UNITED STATES PATENT AND TRADEMARK OFFICE

APPLICATION NO.	FILING DATE	FIRST NAMED INVENTOR	ATTORNEY DOCKET NO.	CONFIRMATION NO.
10/803,811	03/18/2004	Takashi Sasabayashi	2003054A125US	5595

Office Action Summary	Application No.		Applicant(s)	
	10/803,811		SASABAYASHI ET AL.	
	Examiner		Art Unit	
	Thinh T. Nguyen		2818

DETAILED OFFICE ACTION

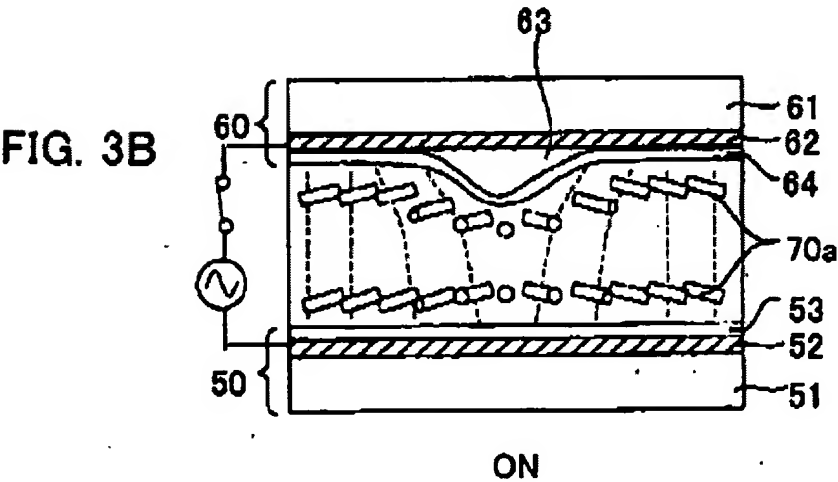
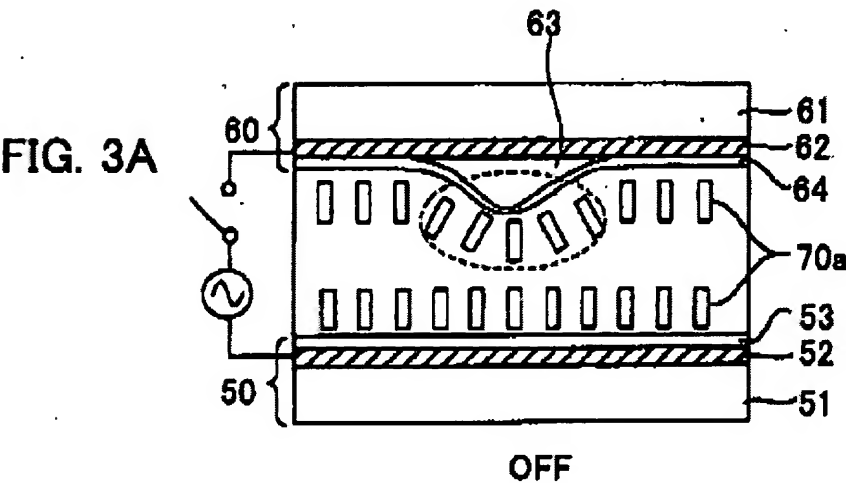
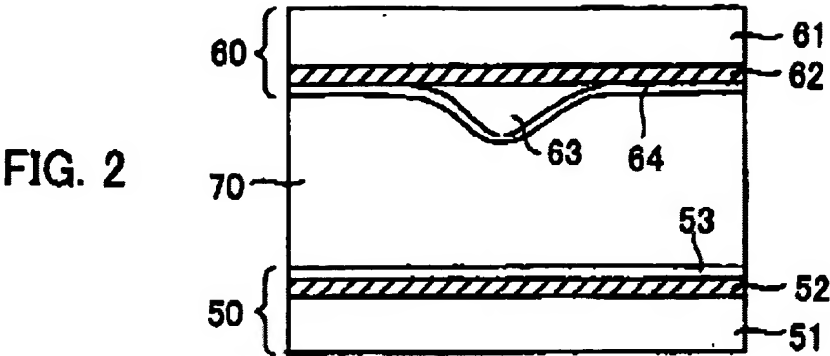
4. The Drawings are objected to because Fig. 1,2,3A,3B,4,5 are not designated by a legend such as “ prior art “. The legend is. necessary in order to clarify what applicant ‘s invention is (see MPEP paragraph 608.02).

7. Claim 14,15,16 are rejected under 35 U.S.C. 102(a) as being anticipated by Applicant Admitted Prior Art or Background art (fig 3A, 3B, page 7 line 2-19 in the BACKGROUND section) (fig 2, fig 3A, 3B, page 7 line 2-19 in the BACKGROUND section)

The AAPA (fig 2, fig 3A, 3B, page 7 line 2-19 in the BACKGROUND section) discloses a liquid crystal display apparatus comprising a first and second substrates (fig 3A reference numeral 61,51) which are disposed facing each other, a liquid crystal (fig 3A layer 70) sealed between said first and second substrates, a first electrode (fig 3A, layer 52) formed on the liquid crystal side surface of the first substrate, a second electrode (fig 3A layer 62) formed on the liquid crystal side surface of the second substrate, alignment control layers (fig 3A layer 53,64) which cover the surfaces of said first and second electrodes and control the alignment direction of the liquid crystal molecules when no voltage is applied to be roughly vertical from the substrate face (fig 3A) , and bumps which are formed on at least one surface of said first and second substrates and determine the tilting directions of the liquid crystal molecules when voltage is applied, (fig 3B) wherein both of said alignment control layers and said bumps are formed by polymerizing a polymerizable compound which is added to said liquid crystal, and the alignment direction of the liquid crystal molecules near the bumps when no voltage is applied (fig 3A) is roughly vertical from the substrate face.

The AAPA (fig 2,fig 3A, page 6 lines 10-18) discloses a liquid crystal display apparatus wherein both of the first and second substrates and both of the first and second electrodes are transparent.

The AAPA (fig 2,fig 3A, page 6 lines 10-18) discloses a liquid crystal display apparatus wherein at least part of said bumps contacts said first and second substrates.

The AAPA (fig 2, fig 3A, 3B, page 7 line 2-19 in the BACKGROUND section) discloses a liquid crystal display apparatus comprising a first and second substrates which are disposed facing each other, (fig 3A reference 51,61) a liquid crystal sealed between said first and second substrates (fig 2 reference 70) , tilt control sections which are disposed on at least one of said first and second substrates and determine the tilting directions of the liquid crystal molecules when voltage is applied, and alignment control layers (layer 64,53) which are formed on the liquid crystal side faces of the first and second substrates and control the alignment direction of the liquid crystal molecules when no voltage is applied to be roughly vertical from the substrate face, wherein said alignment control layers are formed by polymerizing a polymerizable compound which is added to said liquid crystal.

The AAPA (fig 2, fig 3A, 3B,) discloses a liquid crystal display apparatus wherein the tilt control sections are bumps or dents installed on at least one of the first and second substrates.

Claims 25-26 have the limitation of product by process and are considered non-limitations as set forth in paragraph 6 of the Office Action therefore the AAPA (fig 2,fig 3A,fig 3B) correctly anticipated claims 25,26.
